**SUBDIVISION REVIEW SHEET****CASE NO.:** C8-2022-0318.0A**COMMISSION DATE:** May 2, 2023**SUBDIVISION NAME:** Maxwell Subdivision**ADDRESS:** 2114 Maxwell Lane**APPLICANT:** ZHN Investment LLC (Lynn Yuan)**AGENT:** LOC Consultants (Sergio Lozano, P.E.)**ZONING:** SF-3 (single family) (Cottage Lot)**NEIGHBORHOOD PLAN:** Montopolis**AREA:** 0.59 acres (25, 686 sf)**LOTS:** 5**COUNTY:** Travis**DISTRICT:** 3**WATERSHED:** Carson Creek**JURISDICTION:** Full Purpose**SIDEWALKS:** Sidewalks will be constructed along streets.**VARIANCE:** None**DEPARTMENT COMMENTS:**

**CITY OF AUSTIN –DEVELOPMENT SERVICES DEPARTMENT  
SUBDIVISION APPLICATION – MASTER COMMENT REPORT**

CASE NUMBER: C8-2022-0318.0A  
UPDATE: U1  
CASE MANAGER: Cesar Zavala Email: cesar.zavala@austintexas.gov

PROJECT NAME: Maxwell Subdivision  
LOCATION: 2114 Maxwell Lane

FINAL PLAT  
MAXWELL SUBDIVISION

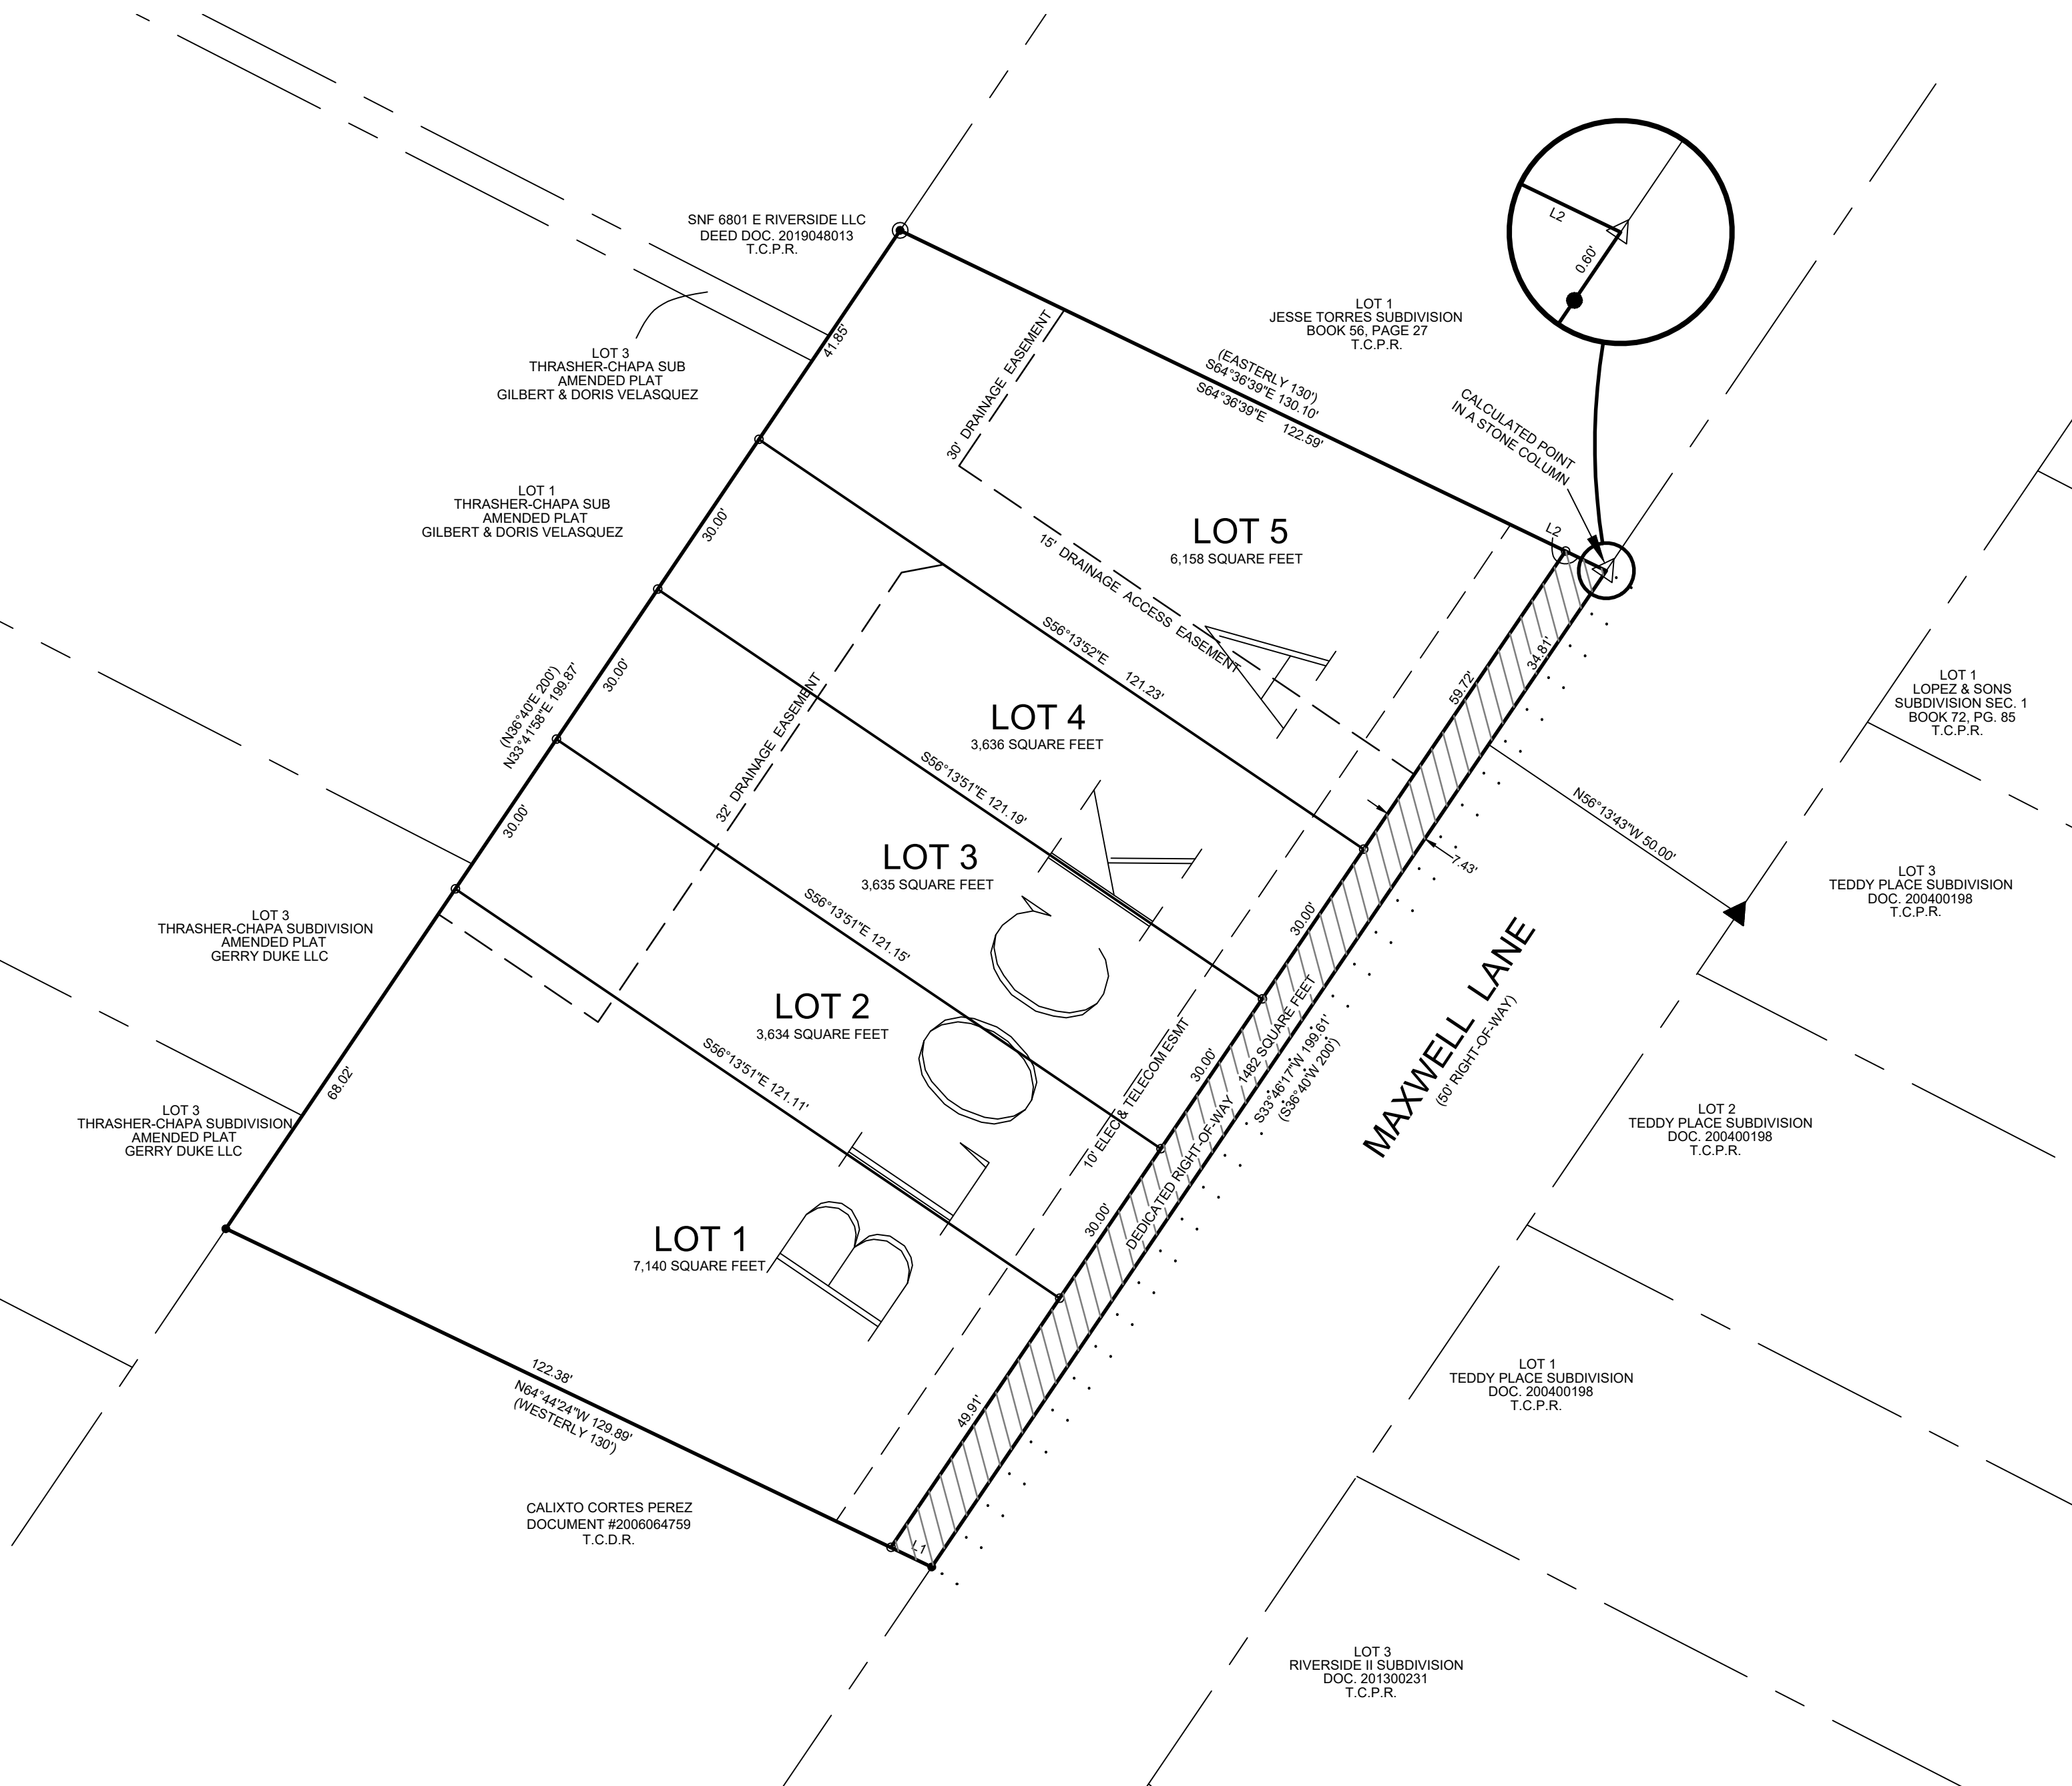
ATD 3. The ASMP requires **58 feet** of right-of-way for Maxwell Lane. Dedicate 29 feet of right-of-way from the centerline in accordance with the ASMP (LDC 25-6-55). Please specify the length of right-of-way.

ATD 4. A sidewalk easement is required if the public sidewalk enters onto private property. Provide an additional two feet within the easement for maintenance purposes. TCM, 4.1.1, 4.1.2. (*Determine if the sidewalk easement requires maintenance (i.e. "with maintenance"). Otherwise add 2-additional feet*). Please clarify whether this sidewalk enters private property.

ATD 5. Show the standard sidewalk detail (COA Standard No. 432S-1, adopted 3/26/2008).

**U1: Response states, "DE with Required Maintenance Agmt (now proposed across all lots)." The Drainage Easement with Required Maintenance Document, Exhibit A, shows the outdated easement boundary (L4, 5.05' wide and 668 sf). Also, the plat appears to dedicate the easement, because it is missing a separate instrument document number on the plat. Please clarify if the proposed easement is by plat or separate instrument.**

- SR 12. **Update 1:** Provide a copy of the current deed for the property. 25-1-83 (or 30-1-113) and TX LGC 212.004(c)
- SR 13. **Update 1:** Update the owner's preamble on the plat to list the owner listed on the current deed and the correct document number. 25-1-83 (or 30-1-113) and TX LGC 212.004(c)
- SR 14. **Update 1:** If a covenants and conditions document or Homeowner's Association document will recorded with the plat, add a note stating that the document was filed and on the note include a field or line to include the document recording number. The document will need to be provided with the items for recording the plat. 25-1-83

**U1. Comment Cleared.**

**U1. Comment Cleared.**

**U1. Comment Cleared.**
